Access Compliance Report Public Rights-of-Way (Curb Ramps)

Main Street: N/A Cross Street: RED_HILL_AVE Location: N

ADA ID: RPRK220107115043 Ramp Type: Type 6 - Directional 1 Initial Pass/Fail: Pass Overall Compliance: No Severity Score: 16

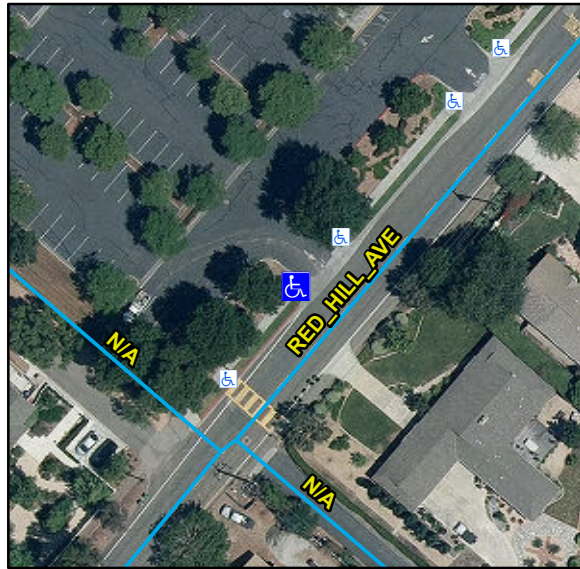
Remove & Replace Entire Ramp. Remove & Replace Gutter.

R304.2.2-Perp, R304.3.2-Para, R304.5.2, R305, R304.5.4, R304.5.3, STD 1115
